**Re: Lot 12, Block 1, Unit 2, Chamisa Ridge, 6216 Wild Onion Ave. NW
Grading and Drainage Plan
Engineer's Stamp dated 08-03-2013 (B-10/D002B)**

**RE: Lot 12, Block 1, Unit 2, Chamisa Ridge Grading & Drainage Plan, 6216
Wild Onion Ave. NW (B10/D002B)**

SANDOVAL COUNTY	NEW MEXICO
LOT 12, BLOCK 1, UNIT 2, CHAMISA RIDGE	
SANDIA BUILDERS - TRUEBA CUSTOM HOME - GRADING & DRAINAGE PLAN	
McDowell Engineering, Inc.	
7820 BEVERLY HILLS AVE. NE • ALBUQUERQUE, NM 87122 TELE: 505-828-2430 • FAX: 505-821-4857	
Designed JSM	Drawn STAFF
Checked JSM	Sheet of
File SANO213L	Date MAY, 2013
1	1

Cross Section Cross Section for Gutter Section

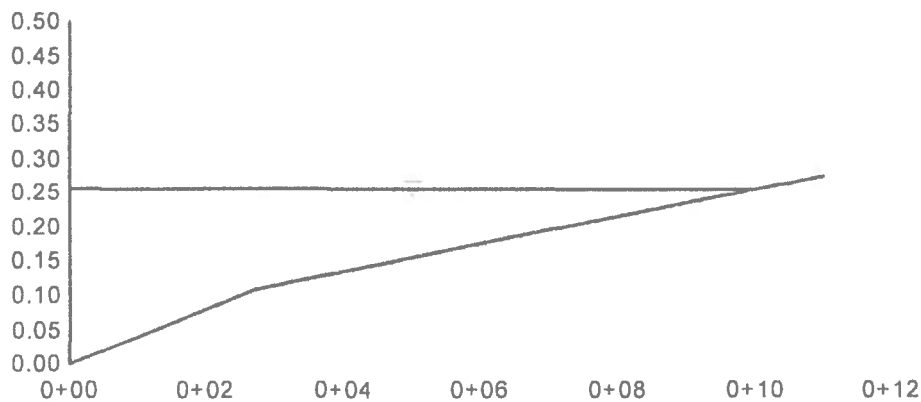
I reviewed your revised Grading and Drainage plan for Lot 12, Block 1, Unit 2, Chamisa Ridge. The elevations provided along Wild Onion are hard to read but it appears that there is only 0.20' of water block.

Will this be adequate for the water block? Provide calculations.

Attached are the street capacity calculations you requested. The survey shows that there is an average gutter flowline to top of curb of 0.25'. The attached analysis shows that there is adequate street capacity to handle the upstream runoff at this location.

$Q_{\text{capacity}} = 4.38 \text{ cfs}$
 $Q_{\text{from upstream basin}} = 4.03 \text{ cfs}$
 \therefore Capacity exists in the street for the upstream flow.

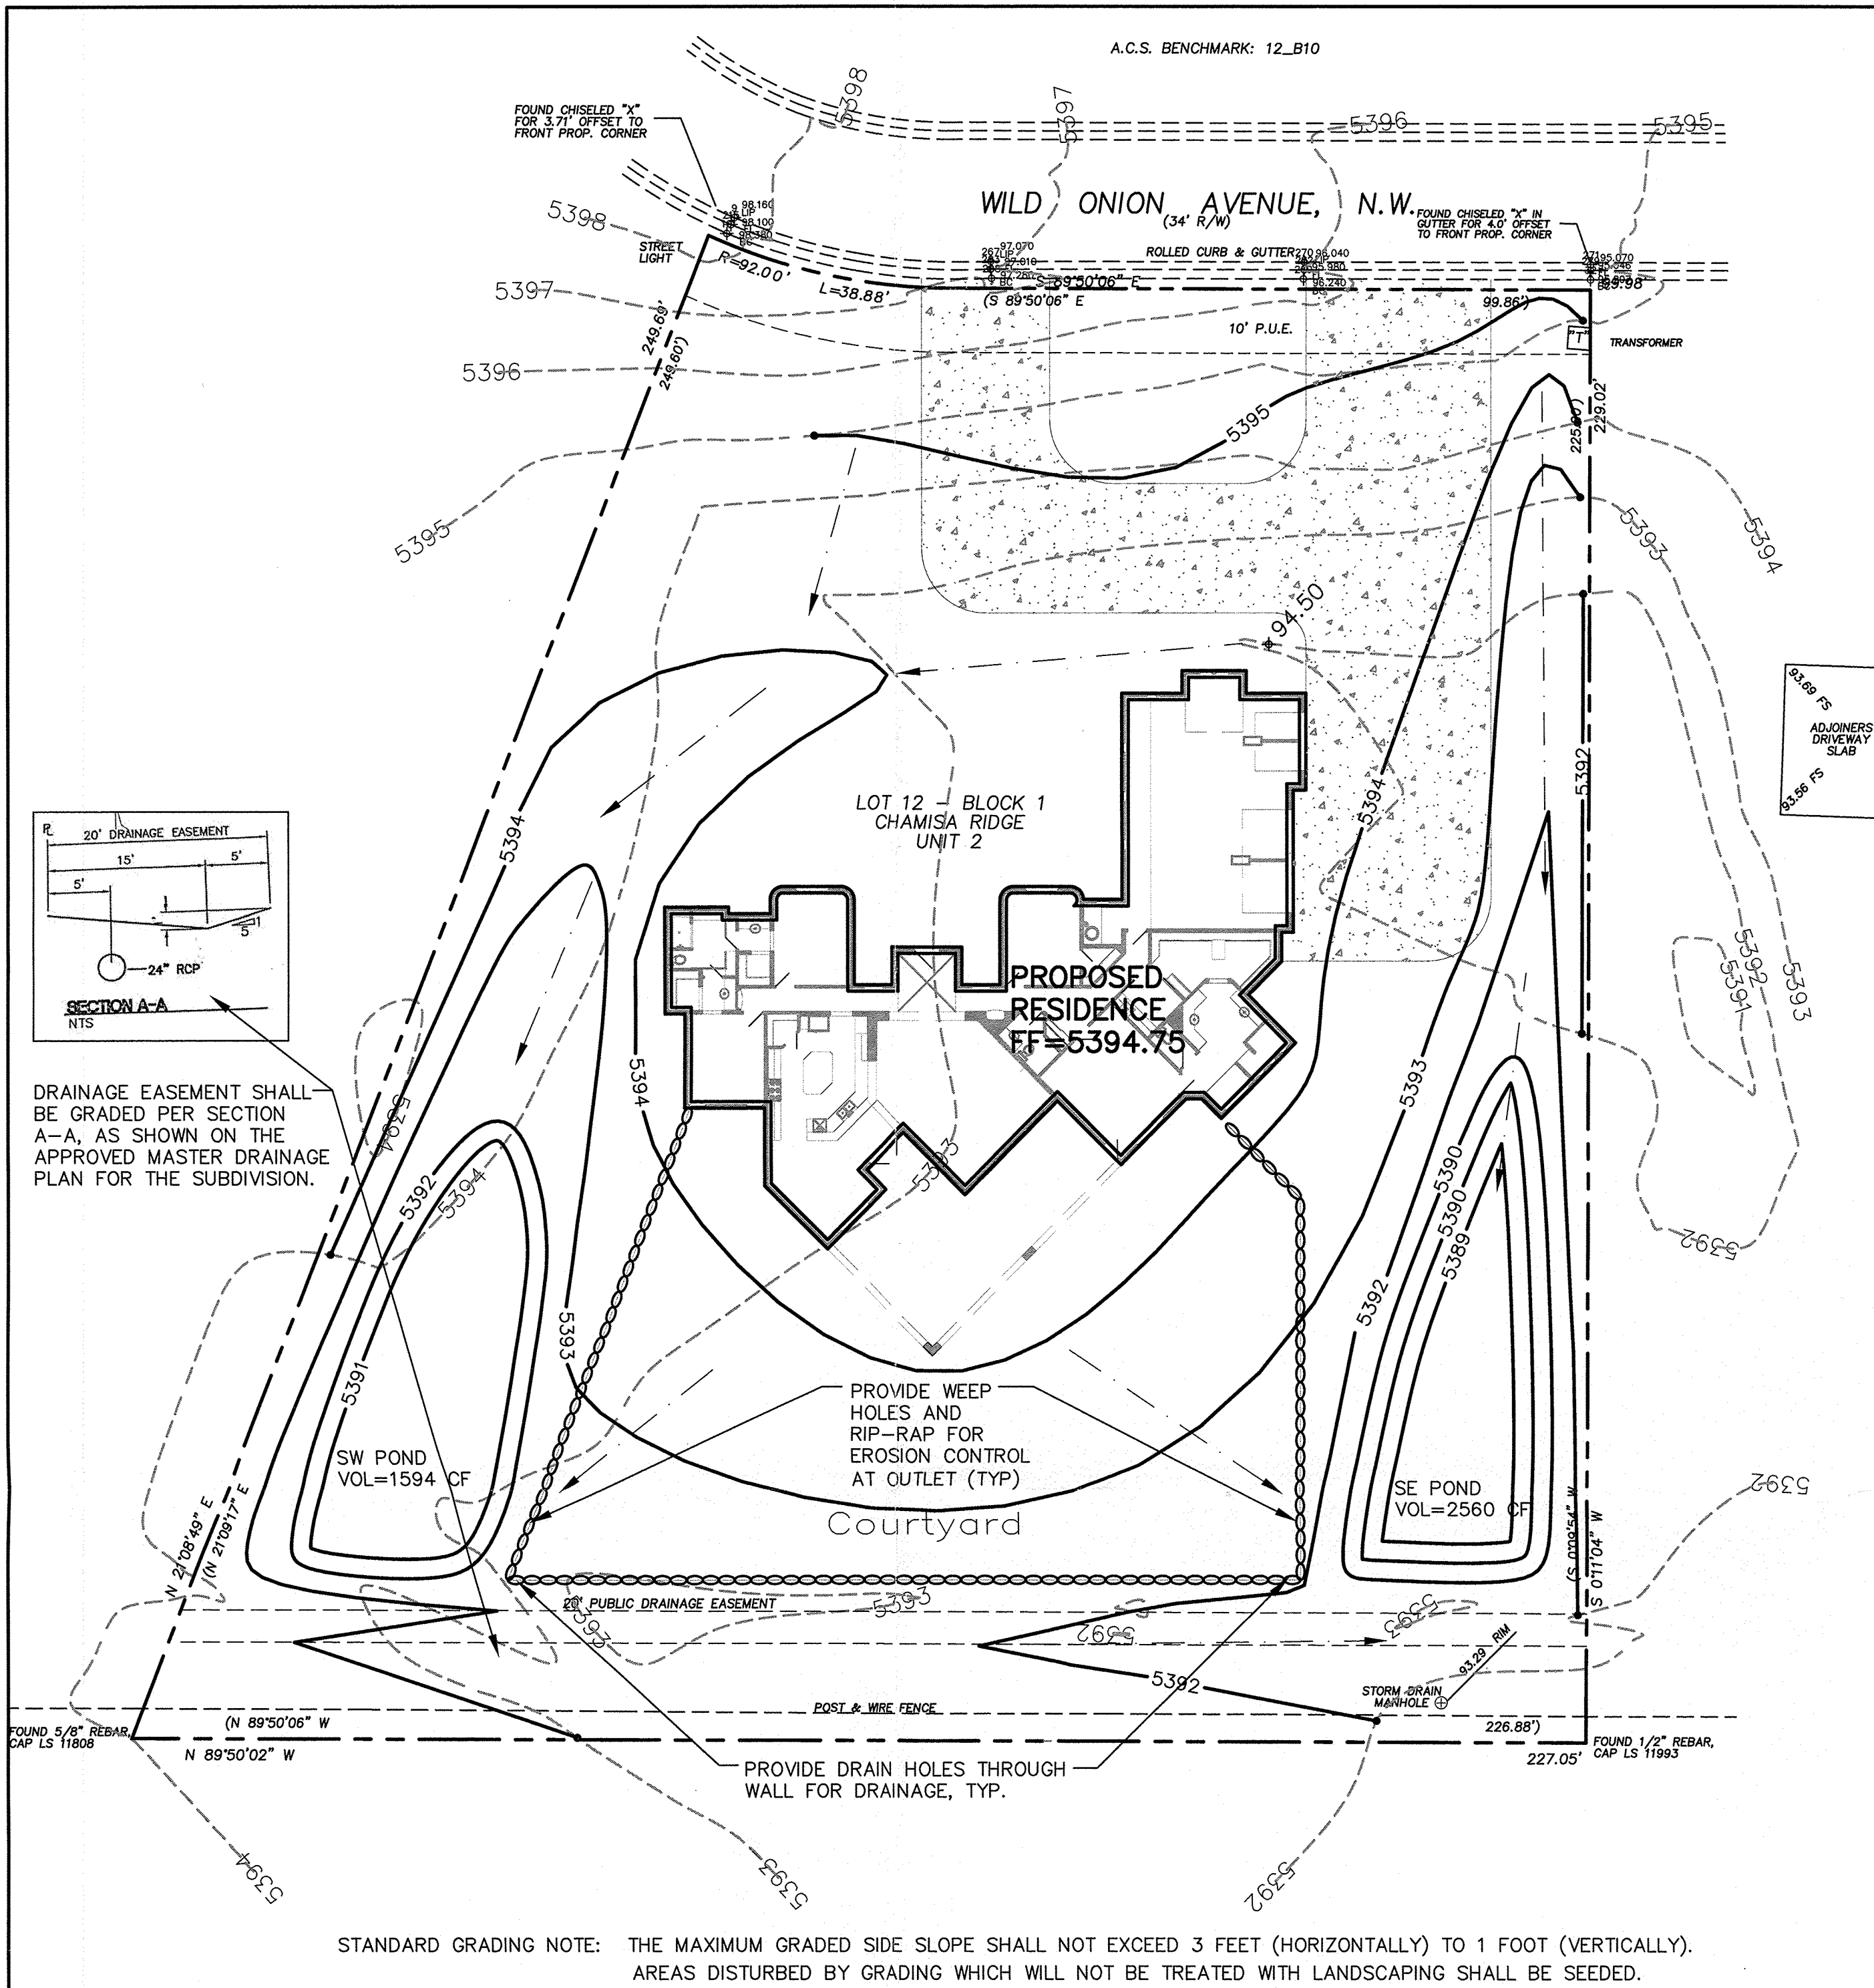
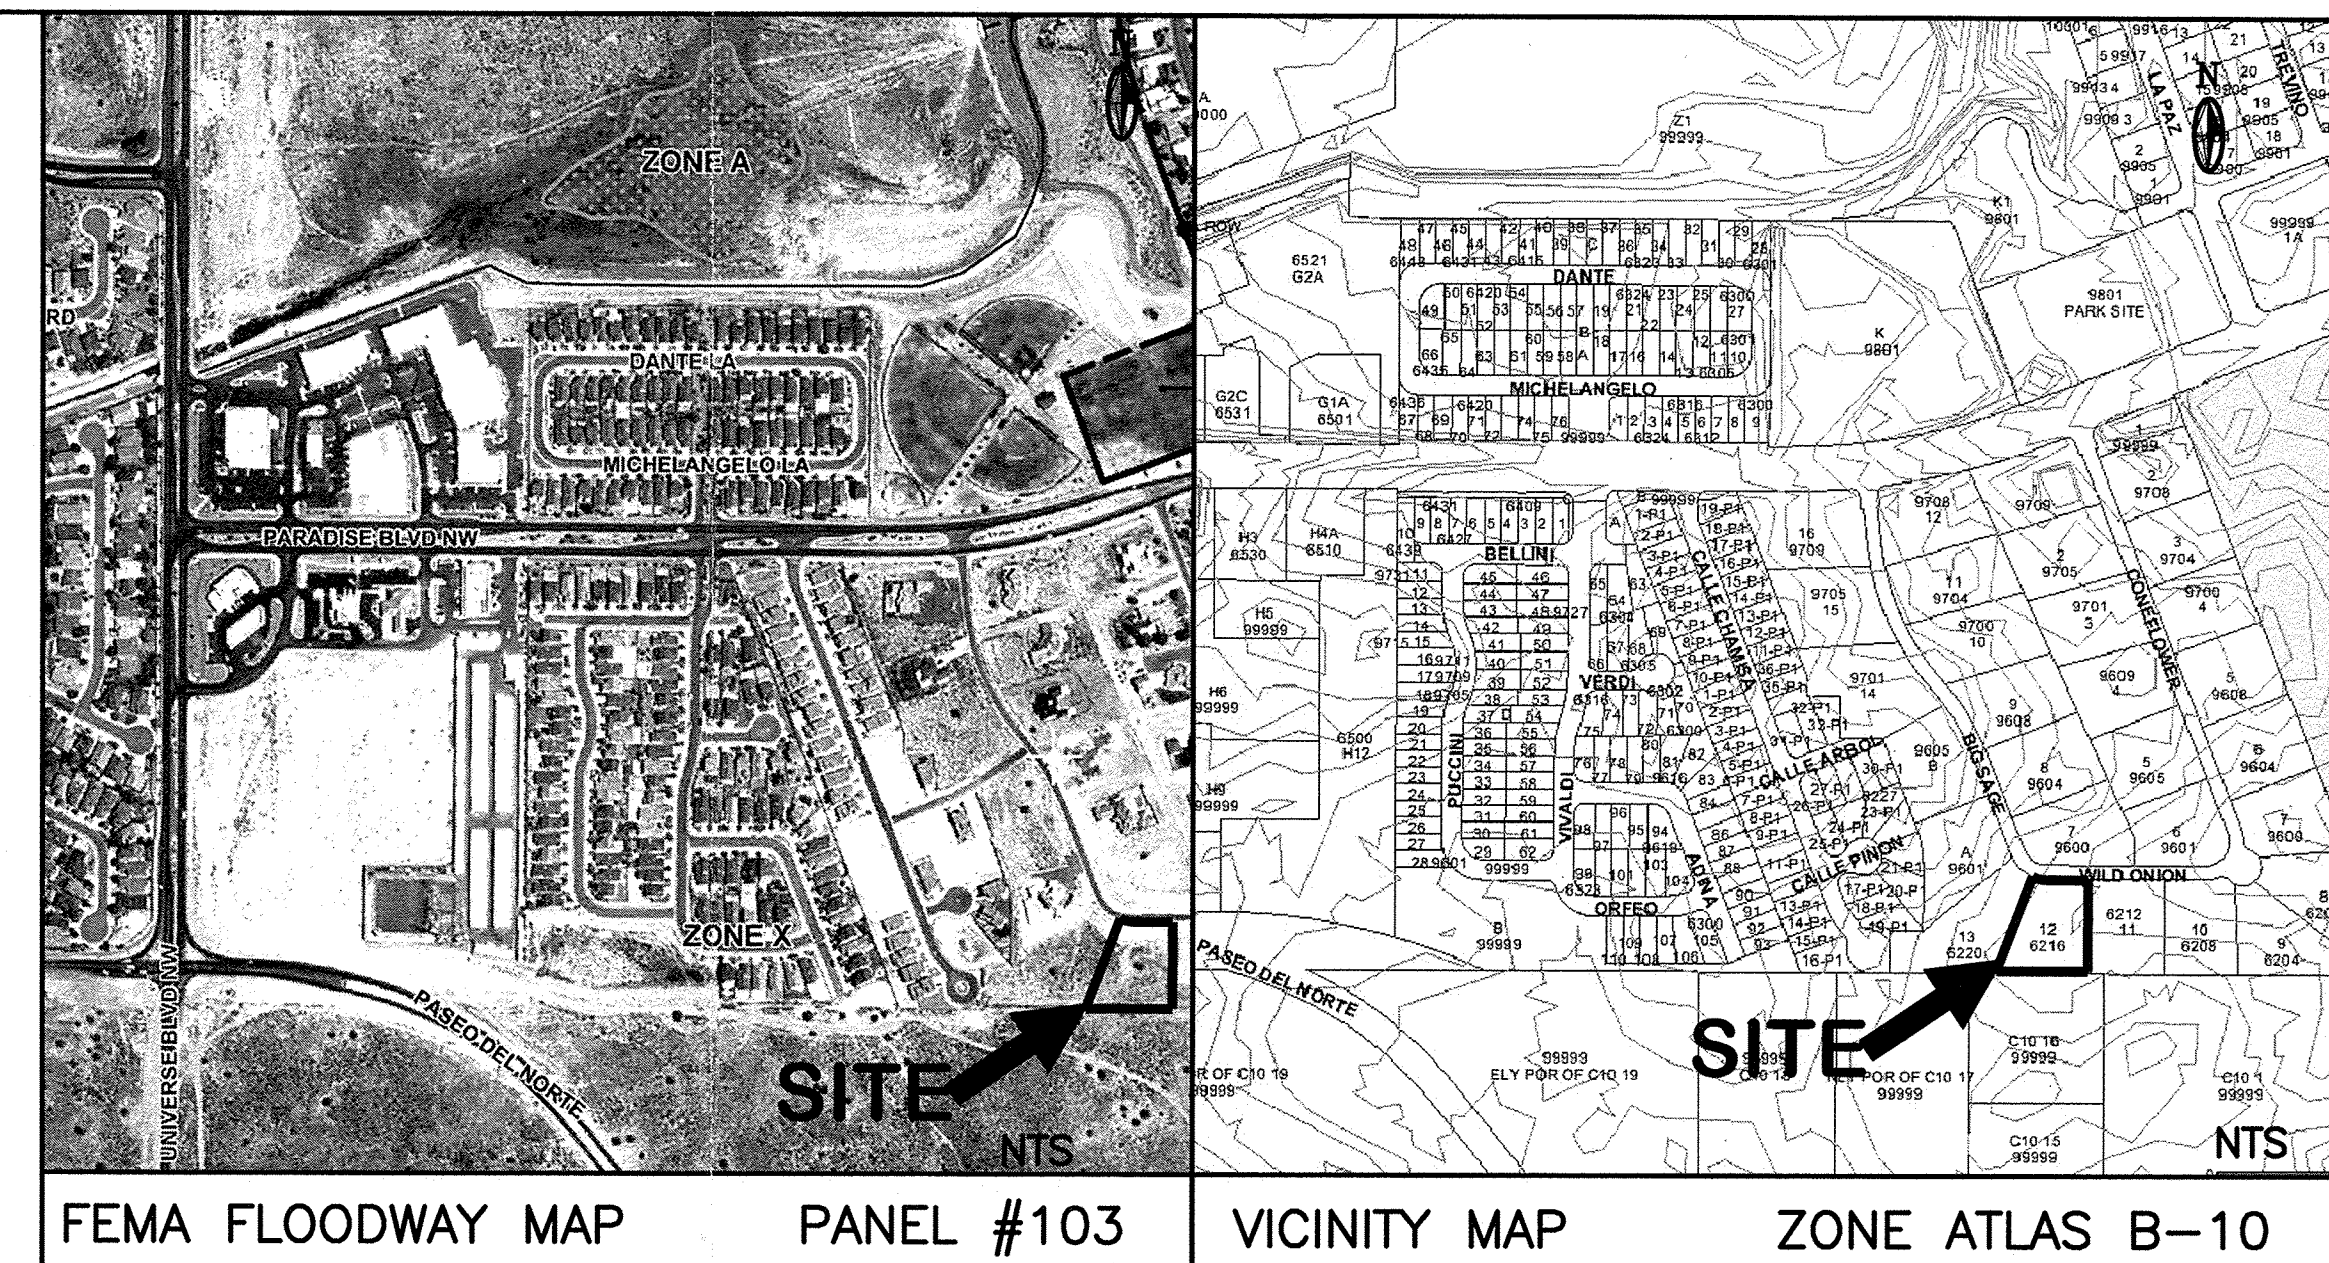
We received your review comments dated July 3, 2013 and offer the following response with the enclosed revised Grading & Drainage Plan.

- We have modified the plan to allow for water harvesting ponds to hold the volume of water generated from a 100 year storm. At this time, the developed runoff cannot be fully conveyed downstream to the detention pond through the existing drainage easement as several lots downstream have not been graded to allow for this conveyance per our discussion on August 2, 2013.
- Top of curb and flowline elevations have been added to Wild Onion Ave. to show that an adequate water block exists.
- All proposed contours have labeled and the font has been enlarged on the existing contours to be more legible.
